Addendum #1

Date: November 19, 2021
Project: **Offsite Waterline Supply**
Lukachukai Community School Replacement
Location: Indian Route 12
Lukachukai, AZ 86507

RE: LCS & NHA Offsite Waterline, Lukachukai AZ – NTUA-HQ Review @ 'Pre-Final' Submittal

DRAWN BY: JTL
REVIEWED BY: NDR
DATE: 09/03/2021
PROJECT NO.: 20-7002.001
DRAWING NAME: LCS WATERLINE SUPPLY
PLAN & PROFILE
STA 43+00 TO STA 54+00
SHEET NO. C-04

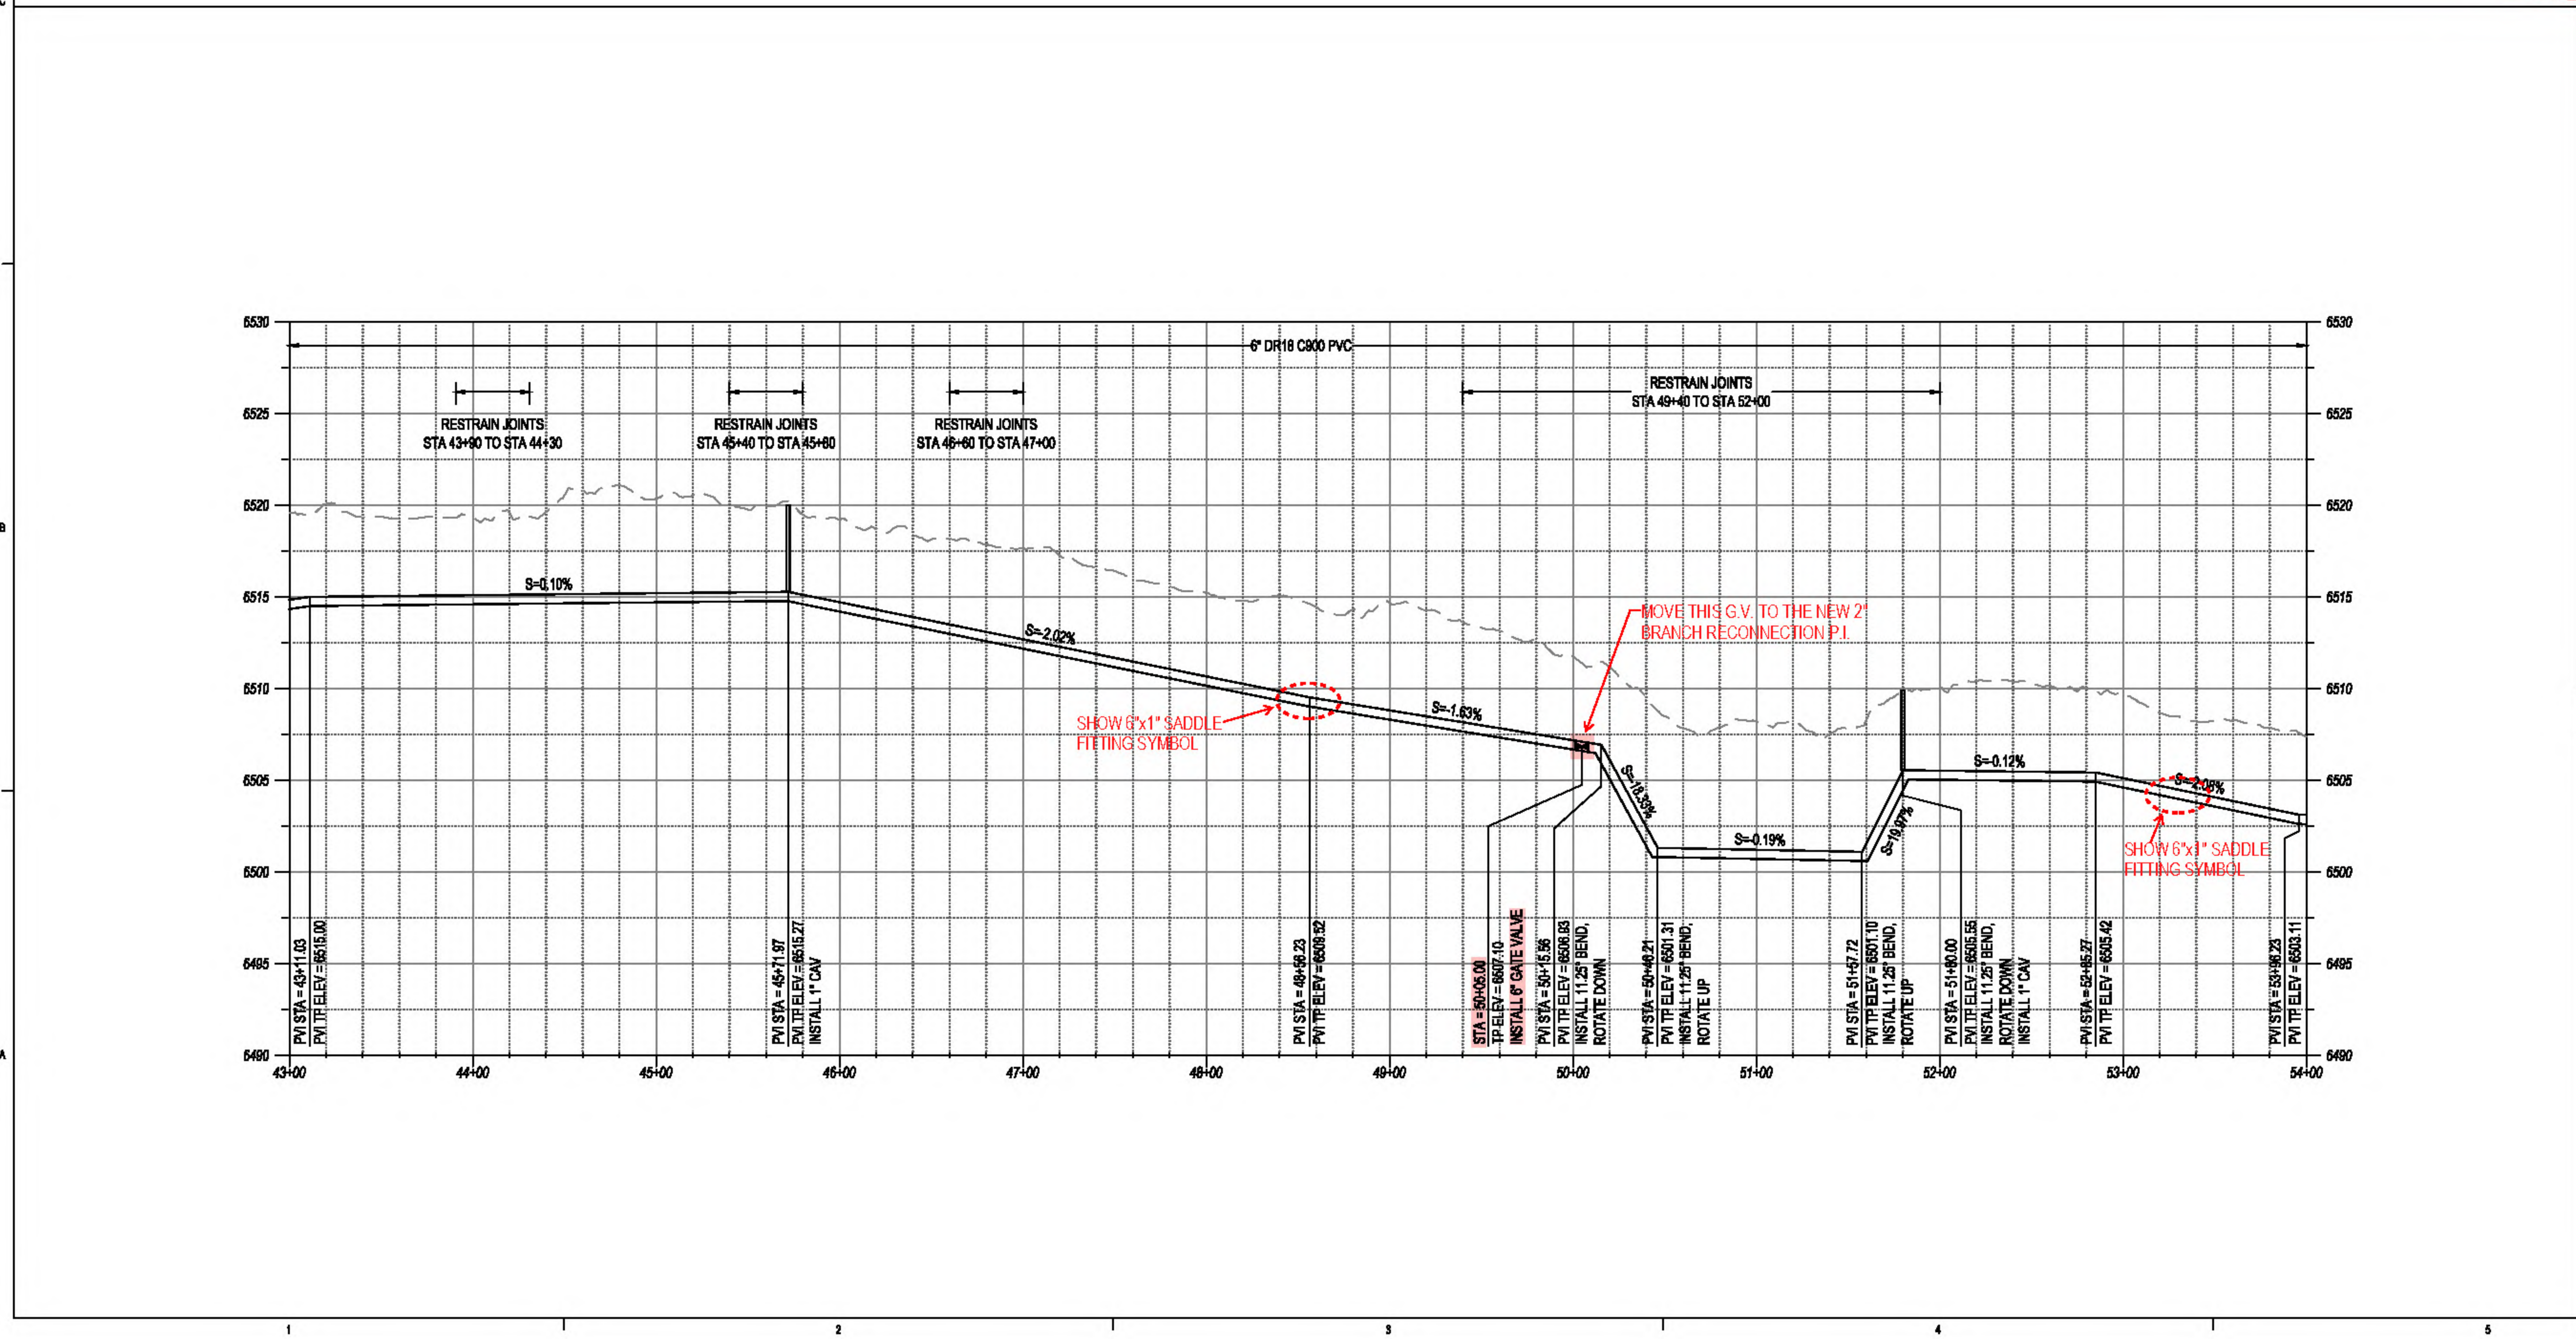
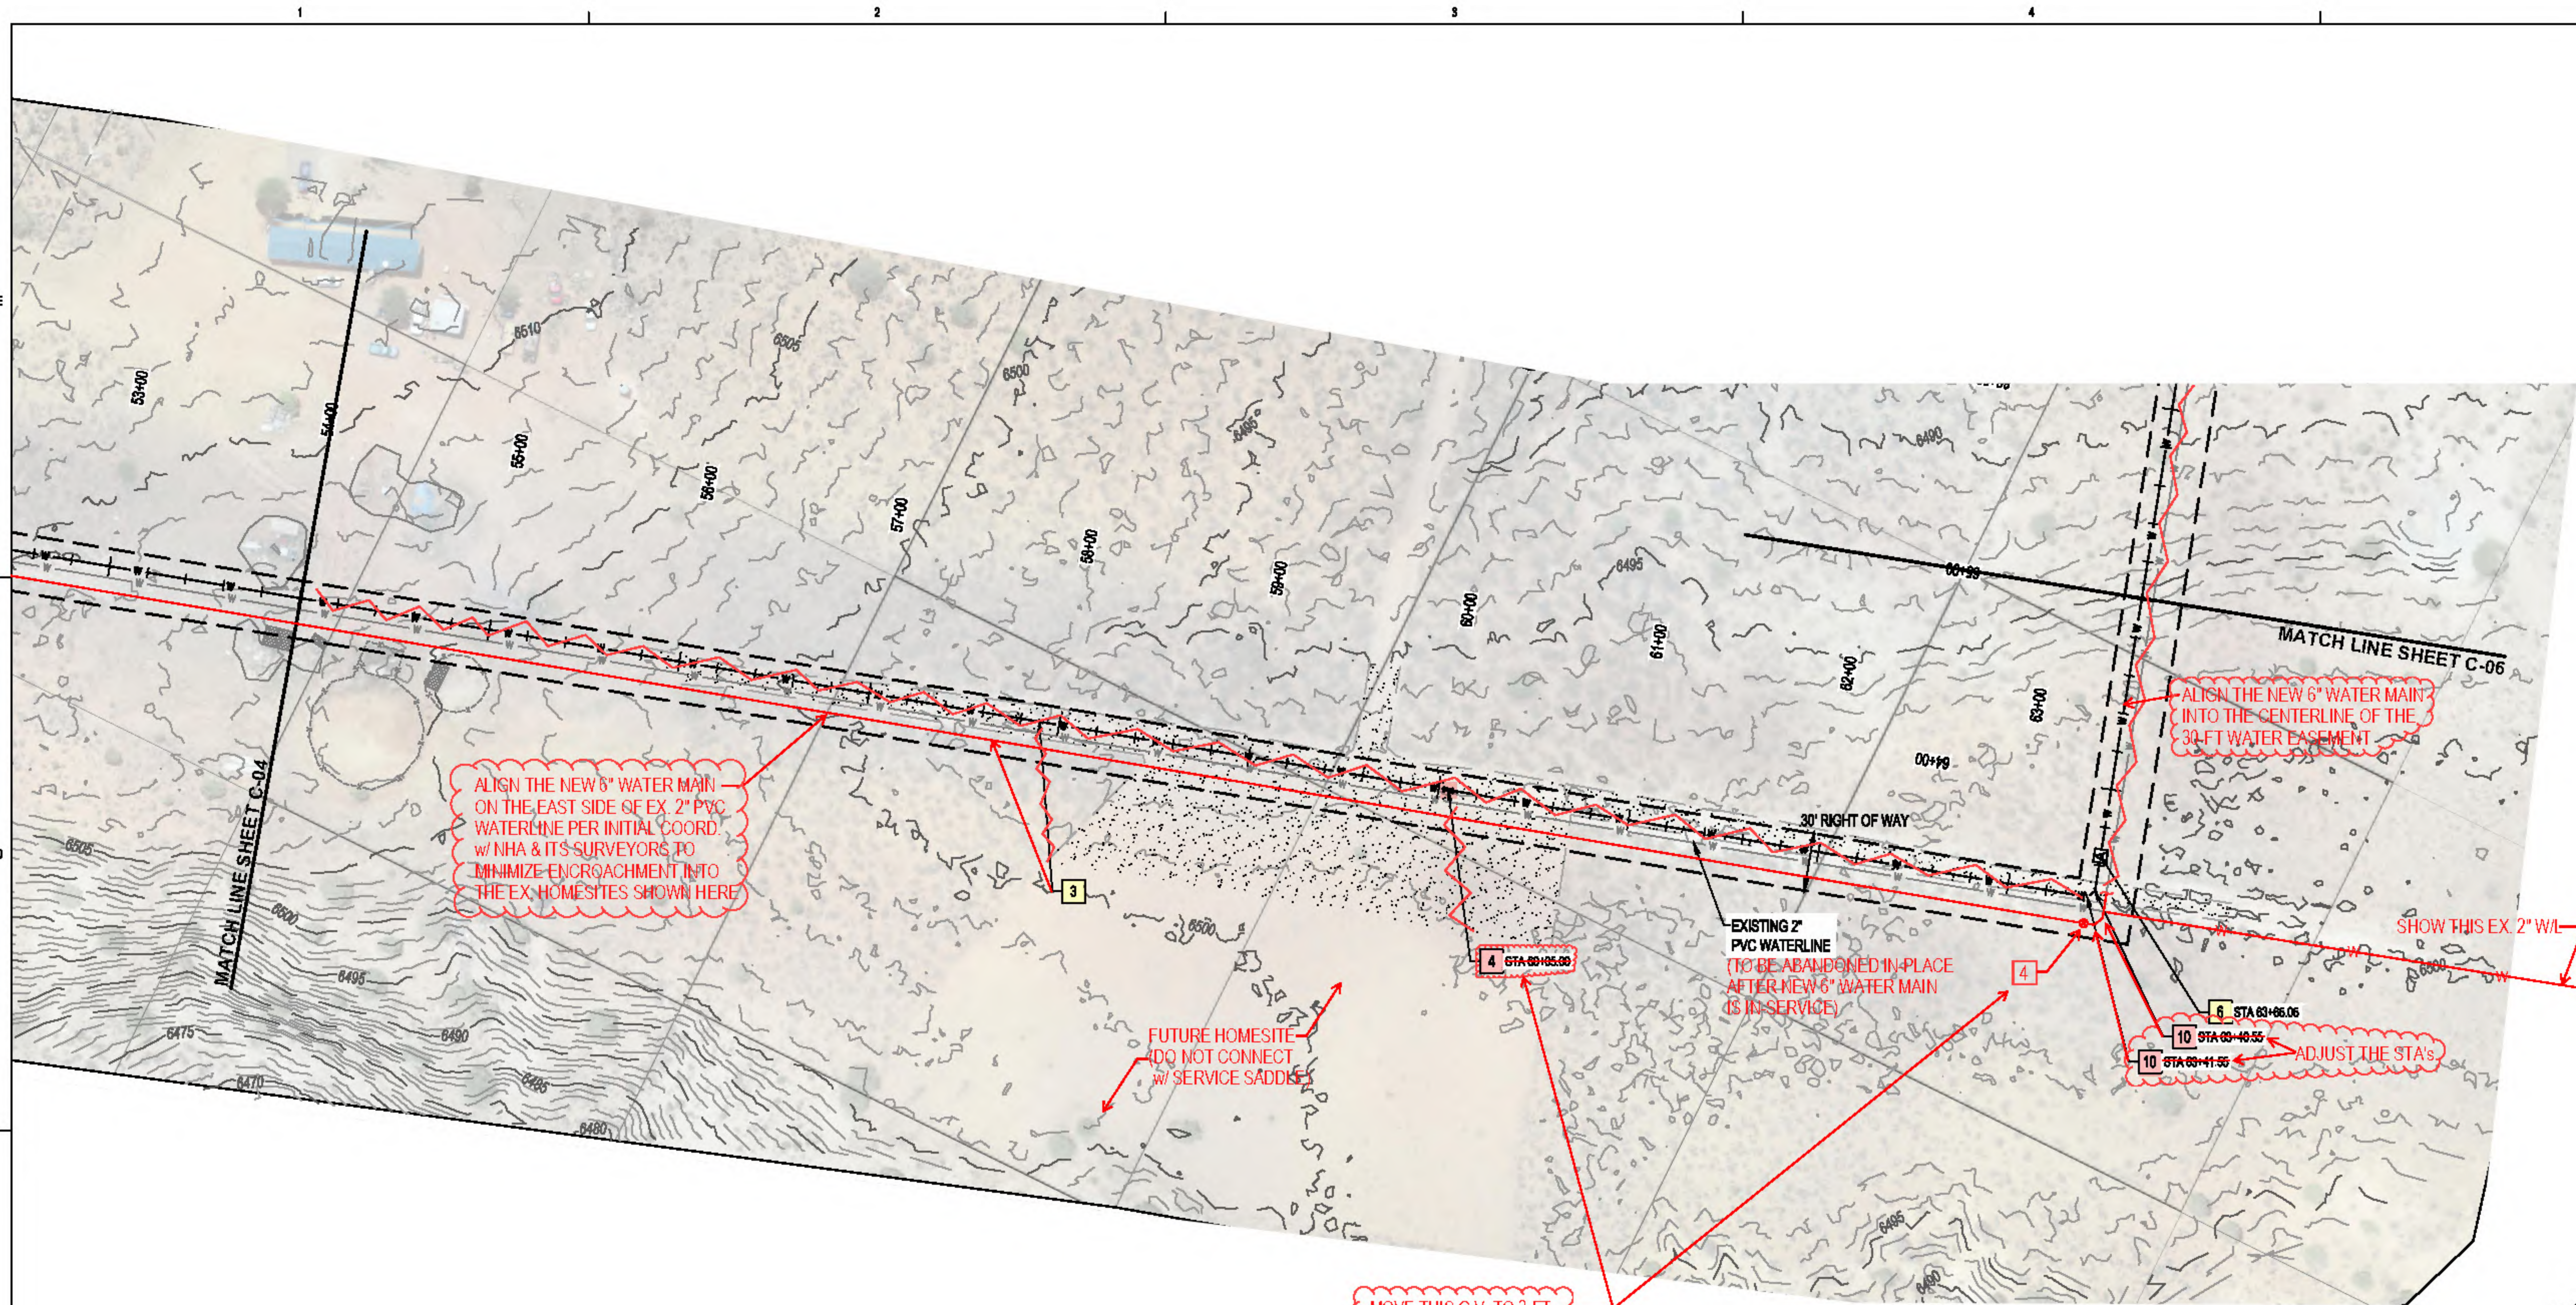
1. Non-existing 2" PVC W/L: Delete/erase the shown ex. 2" waterline alignment that is shown from Sta. 43+00 to Sta. 47+05(+/-), which is from the left matchline of this sheet to the area where the ex. 2" waterline comes in from the north and bends w/ a 45° degree ell heading southwest towards the EOL of this ex. 2" waterline. This segment does not exist in the field.

2. New 6" PVC C900 W/L alignment:
 - From Sta. 43+00 (left matchline) to Sta. 46+45(+/-): Align the new 6" water main at the centerline of the new 30-ft water easement/ROW.

- From Sta. 46+45(+/-) to Sta. 54+00 (right matchline for this sheet), align the new 6" water main on the eastern side of the incoming northern ex. 2" waterline (5 to 6-ft offset) within the ex. 30-ft water easement/ROW. This is per initial coordination w/ the NHA and its surveyors to minimize encroachment into the ex. Homesites within this alignment area.

3. Ex. northern 2" PVC W/L label (from Sta. 47+05(+/-) to right matchline Sta. 54+00): Also callout this particular waterline to be 'abandoned in-place' as shown on the plan sheet.

4. The ex. 2" waterline segment after the 45° degree bend to the EOL that serves the ex. Homesite with the maroon roof near Sta. 45+00 is to remain. Show this ex. 2" waterline and the ex. 30-ft water easement/ROW on the plan as shown. Also show the ex. flush valve and ex. curb stop at the EOL.

5. The reconnection of the ex. 2" waterline (Line "B") to the new 6" water main shall be accomplished by installing a new 6"x2" Tee at/near Sta. 47+00 and a new 2" Gate Valve at 3-ft downstream of the new tee as shown on the plan sheet. After the new gate valve, install new 2" PVC SDR-21 pipe as needed to where the new 2" branch intersects with the ex. 2" waterline alignment. At this point, install a new 45° bend w/ a min. 5-ft segment of 2" PVC SDR-21 transition piping w/ appropriate 2" coupling to re-connect back to the ex. 2" waterline serving the Homesite at the EOL.
It is requested to blow up this new P.I. area with a detail bubble as shown on the plan sheet. Show/add the detail bubble review comments as shown per the ex./new water facilities near this P.I.

6. Ex. Shed at/near Sta. 47+10(+/-) right: The ex. shed assembly will be required to be moved/relocated for the installation of the new 6" water main. The input/advice of the Homesite owner will be requested for the relocation of the shed to an alternate site outside the ex. 30-ft water easement/ROW.

7. Sta. 50+05.00 (Proposed 6" in-line Gate Valve): Move/revise this gate valve to 3-ft downstream of the revised reconnection branch of the ex. 2" waterline that is to remain, at/near Sta. 47+00(+/-).

8. Ex. Curb Stops at ex. Homesites: The ex. curb stops are to remain, protect in-place. The new 6"x1" saddle taps on the new 6" water main will align directly in-line w/ the ex. curb stop locations. Future water service re-connections will utilize the ex. curb stops. Also, label the House No's. # and/or Homeowners names (typ).

9. Ex. 2" Gate Valve on the ex. 2" waterline (Line "B") to be abandoned at/near Sta. 53+05(+/-) is to be removed and salvaged back to the NTUA Chinle District Office.

10. Keyed Notes: Make corrections to the key note descriptions as shown on the plan sheet.

1. Planned fitting symbols: Show/label the new service saddles and all bend symbols in the profile, as shown.

DRAWN BY: JTL
REVIEWED BY: NDR
DATE: 09/03/2021
PROJECT NO.: 20-7002.001
DRAWING NAME: LCS WATERLINE SUPPLY
PLAN & PROFILE
STA 54+00 TO STA 65+00
SHEET NO. C-05 OF

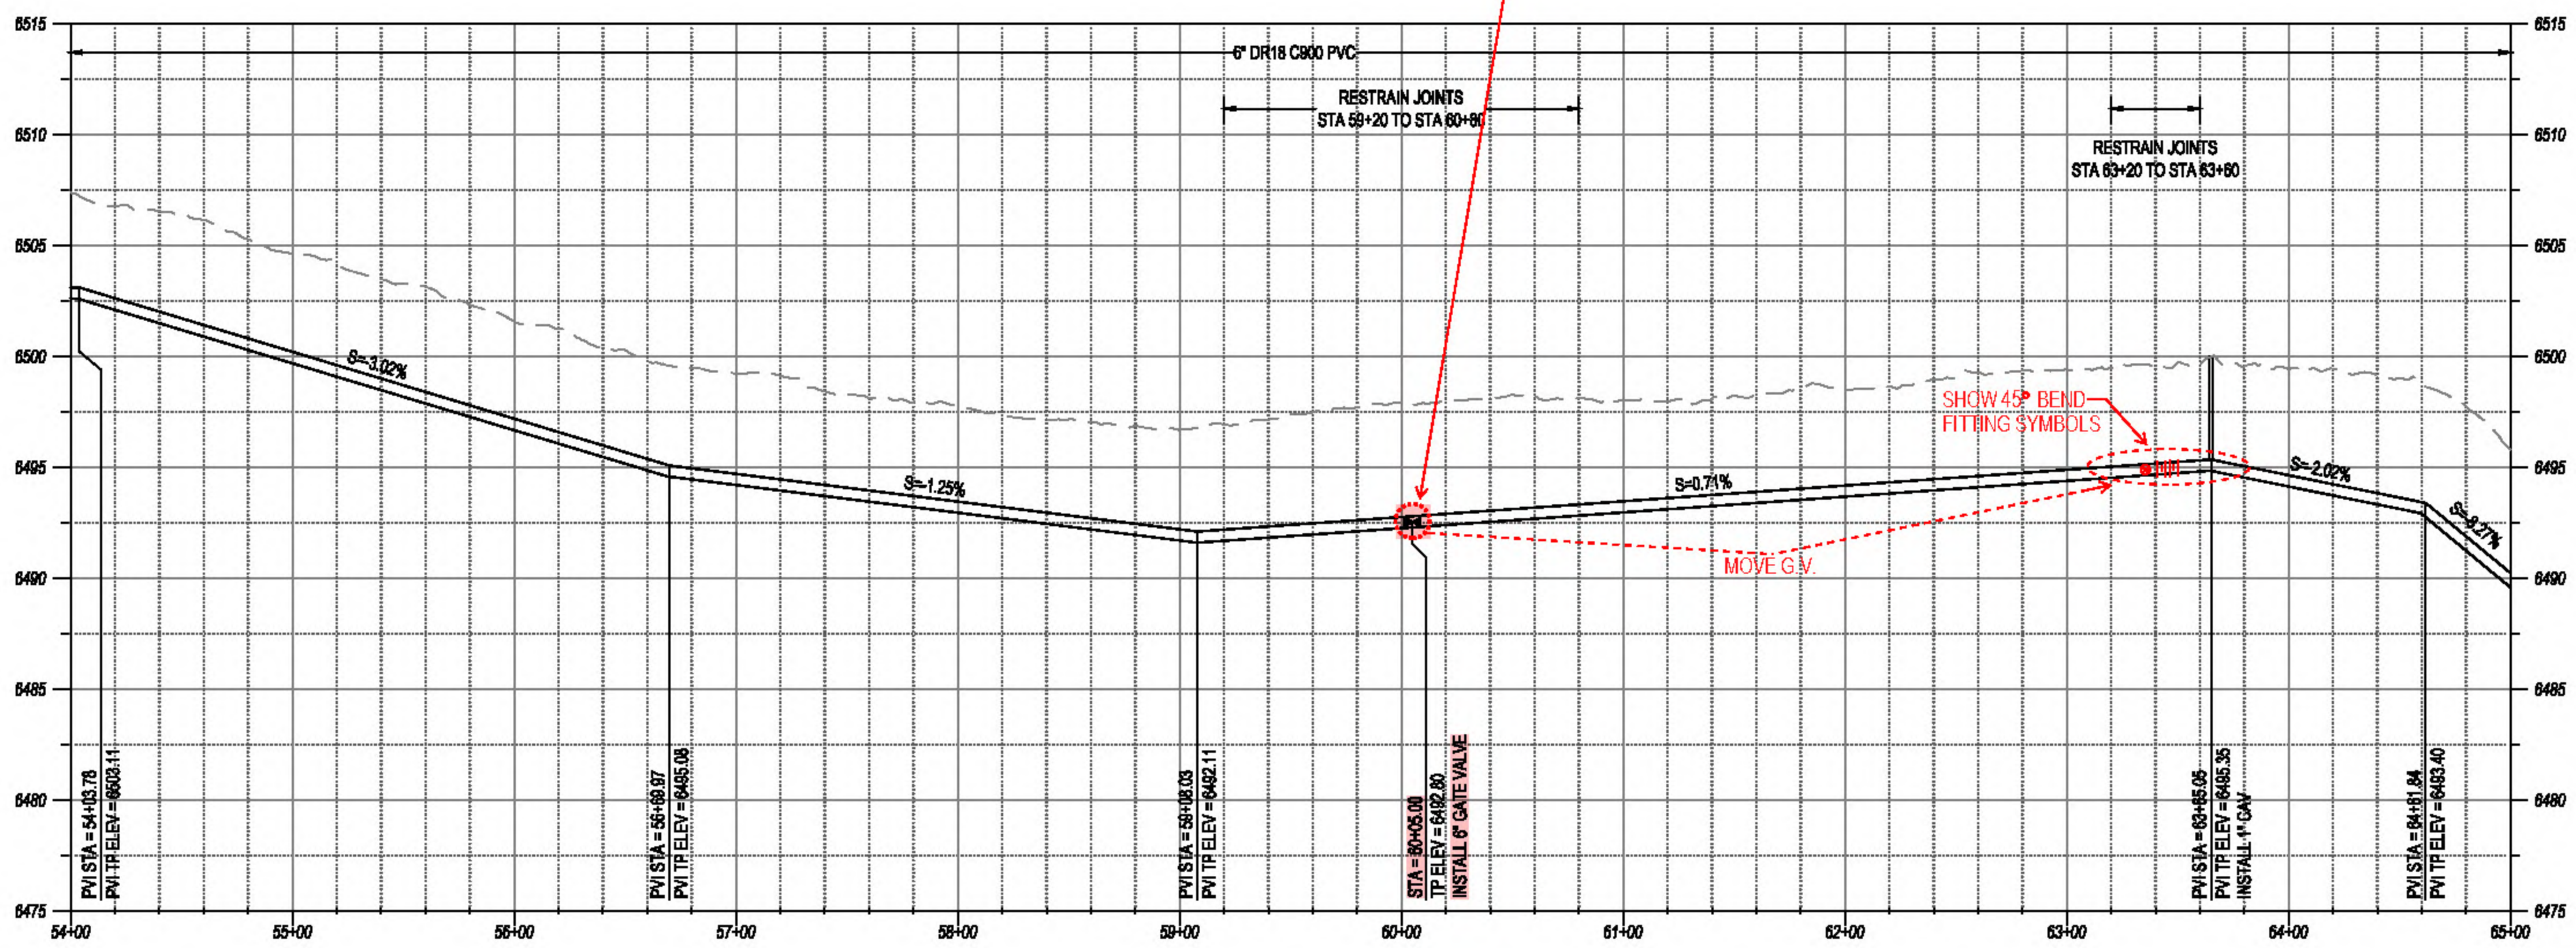
1. New 6" PVC C900 W/L alignment: From Sta. 54+00 to Sta. 63+45 (+/-), align the new 6" water main on the eastern side of the incoming northern ex. 2" waterline (5 to 6-ft offset) within the ex. 30-ft water easement/ROW. This is per initial coordination w/ the NHA and its surveyors to minimize encroachment into the ex. Homesites within this alignment area.
Then after the second 45° bend at/near Sta. 63+50(+/-) to Sta. 65+00 (right matchline for this sheet), align the new 6" water main at the centerline of the new 30-ft water easement/ROW. (The shown ex. 2" waterline does not exist after the 45° bends aligning toward the road crossing for Route N12.

2. Non-existing 2" PVC W/L: Delete/erase the shown ex. 2" waterline alignment that is shown from the non-existing 2" x 90° bend to Sta. 65+00, which is from the right matchline of this sheet. This segment does not exist in the field.

3. Also show the existing 2" waterline (Line "TW-B") that continues to run northbound as shown on the plan sheet. It is requested to enlarge the viewport in this area to show the ex. Homesite to the north. (House #H-364A – Caroline Jim) Once the new 6" water main is in-service and operational, this ex. 2" waterline will end at 10-ft past the ex. water service connection point. At this point a new 2" Flush Valve will be installed for the new EOL.

4. Ex. 2" PVC W/L label: Also callout this particular waterline to be 'abandoned in-place' as shown on the plan sheet.

5. Sta. 60+05.00 (Proposed 6" in-line Gate Valve): Move/revise this gate valve to 3-ft upstream of the first 45° degree bend at/near Sta. 63+45 (+/-).
6. Adjust the Sta.'s for the planned 45° bends once the 6" water main alignment shifts to the center of the 30-ft water easement as shown. Also show the fitting symbols in the profile below.
7. Show the future Homesite near Sta. 59+00/60+00 as shown, but label the homesite not to be served w/ new service saddle as it is not currently connected to the ex. 2" waterline.
8. Keyed Notes: Make corrections to the key note descriptions as shown on the plan sheet.

1. Planned fitting symbols: Show/label the bend symbols in the profile, as shown.

ENLARGE VIEWPORT TO SHOW THE NEXT EX. HOMESITE (HOUSE #H-264A - CAROLINE JIM) TO THE NORTH TO SHOW THE NEW E.O.L. & NEW FLUSH VALVE LOCATION

THIS EX. 2" PVC W/L TO BE ABANDONED IN-PLACE AFTER NEW 6" WATER MAIN IS IN-SERVICE. THE LINE WILL BE ABANDONED @ 10-FT DOWNSTREAM PAST THE NEXT SERVICE LINE TO THE NORTH WITH THE INSTALLATION OF A NEW 2" FLUSH VALVE.
